Title: Advisory Committee on Reactor Safeguards
 ESBWR Col Application Subcommittee

Date: Wednesday, December 3, 2008

ACRS ESBWR Chapter 7 SER w/OI DCD Design Detail and DAC Regulatory Compliance Digital I&C

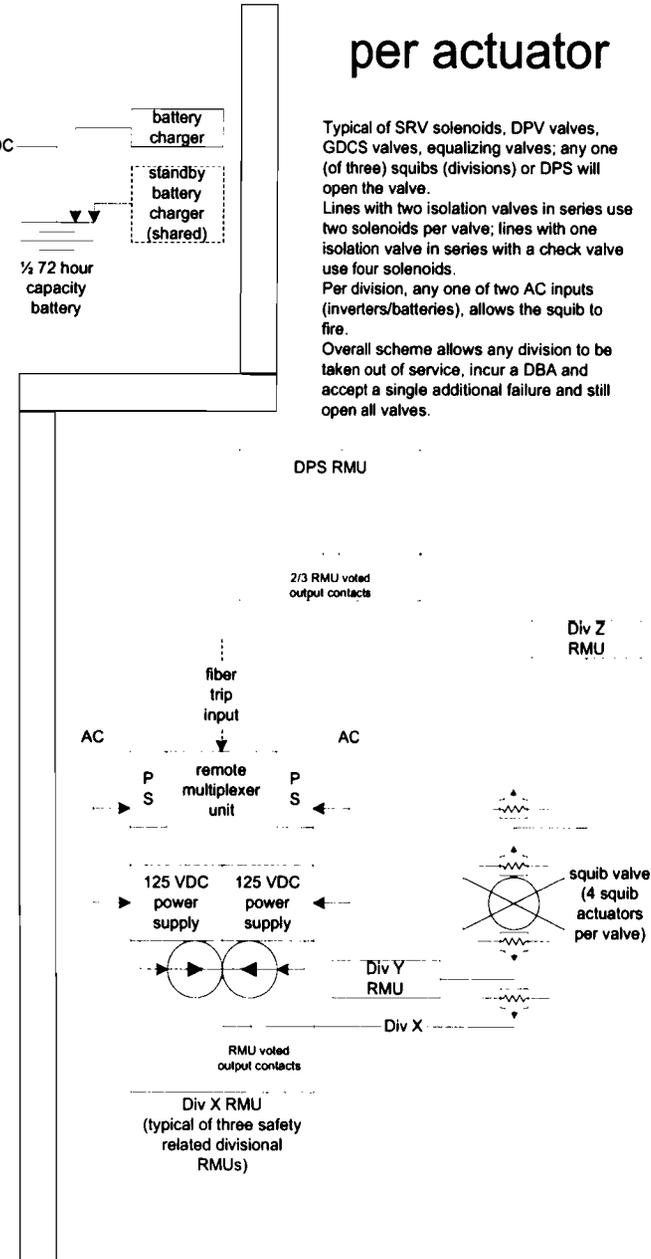
19 MR. POPPEL: Which is kind of a moot
20 point, for the scrams at least because you'll
21 certainly scram well before that. The whole plant is
22 designed -- well, let me go to this thing. I want to
23 make another point. Here is one of our explosive
24 squib valves, and you can see it has four igniters on
25 it, okay? So you could say this is either a

1 depressurization valve or a GDCS valve or whatever,
2 but there's one valve. But the valve is not attached
3 to a division like an active plant. It's not like a
4 motor. It's not like a pump. It's a mechanical valve
5 which can be fired from any one of four inputs. So in
6 other words, division X being out of service says, you
7 know, means this same valve can still be fired from
8 division Y or Z and, in this other case, the diverse
9 protection system. But the point is is that taking
10 that entire division out of service doesn't remove
11 that valve. In fact, taking two divisions out of
12 service doesn't remove that valve.

ESBWR SSLC/ESF Architecture

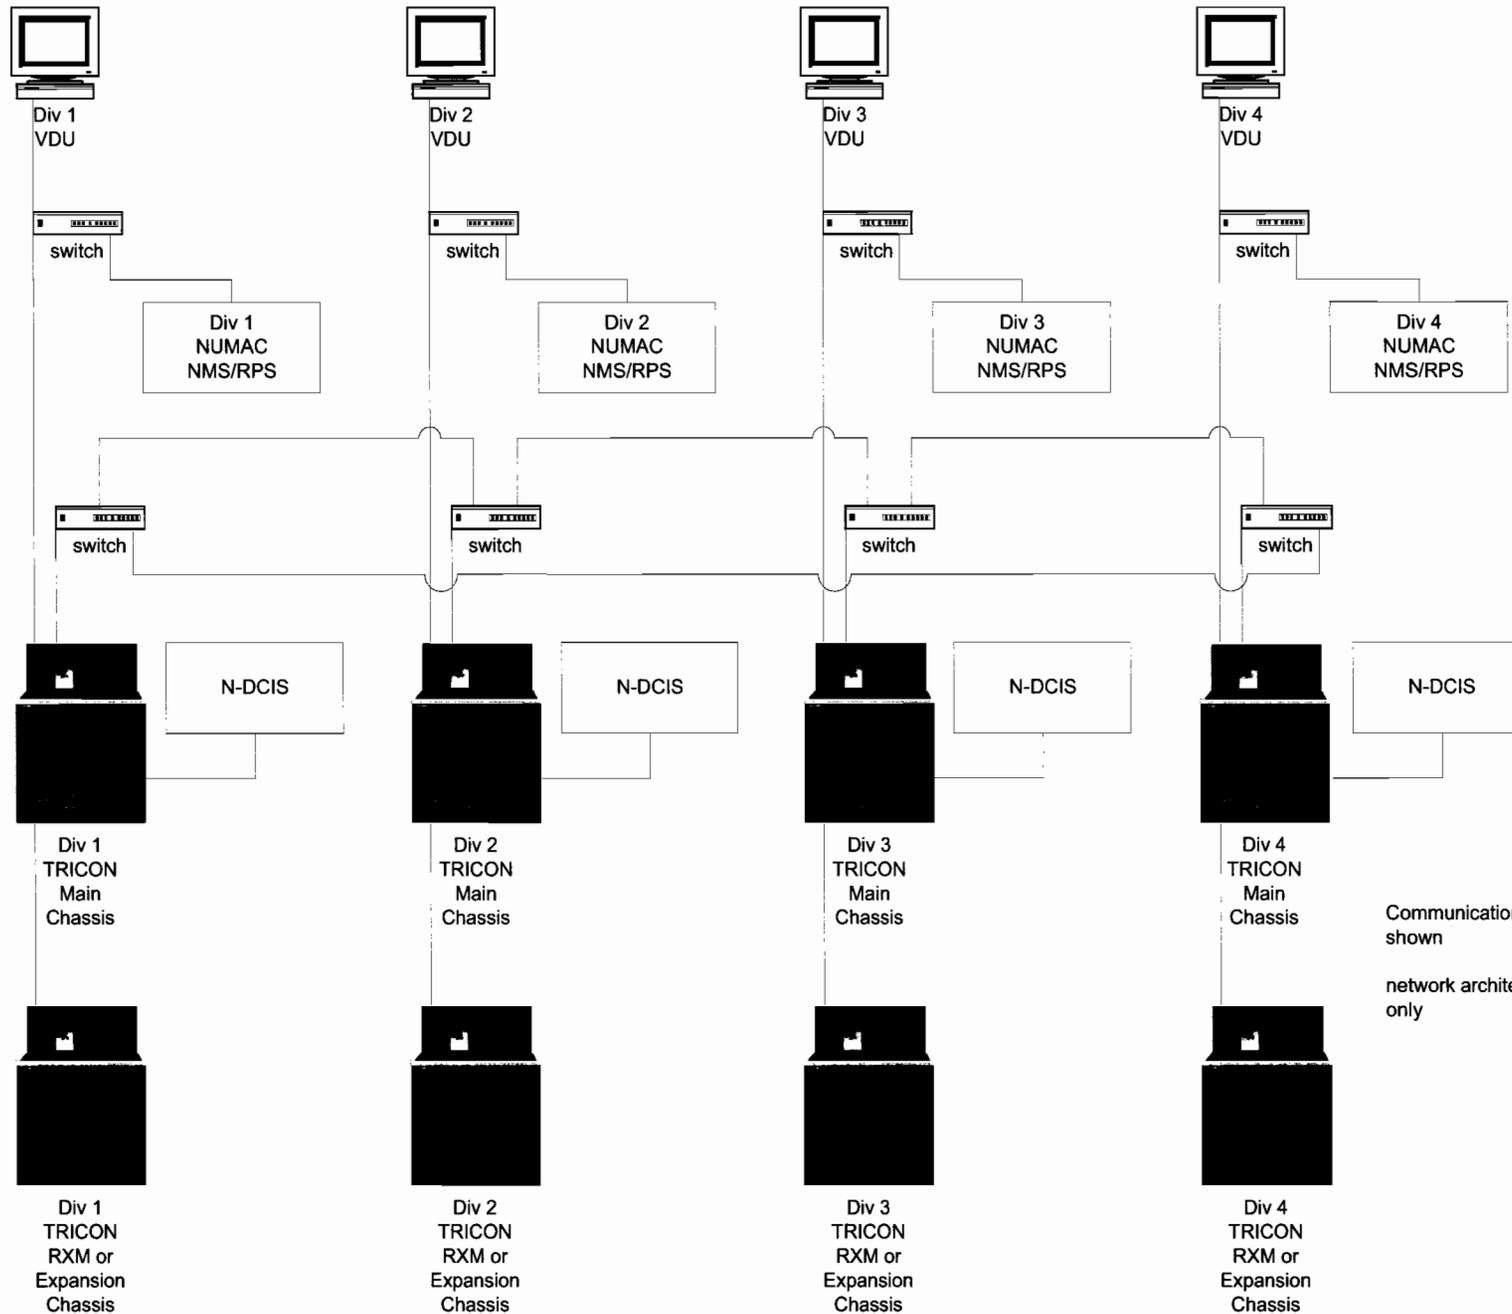
20 There's no explanation. The reason I'm
21 asking this and pulling the strings because there's
22 just no detail on how, what you all's concept and what
23 that means. And the idea that every parameter in
24 every division, whether it's a reactor safety one or
25 engineered safeguards division, should be processed

19 MEMBER BROWN: While you had that other
20 picture -- I'm sorry, Mike. There it is. When I look
21 at this picture and I remember what's in the, there's
22 a figure 7.2-1 in your DCD, although much more
23 compressed, I don't see any network operation within
24 this train for performing its function.

14 MR. POPPEL: No, no, it is the case, but
15 this isn't the picture to show the data flow. This is
16 power, and this is to demonstrate how a single
17 mechanical actuator can handle multiple divisions.
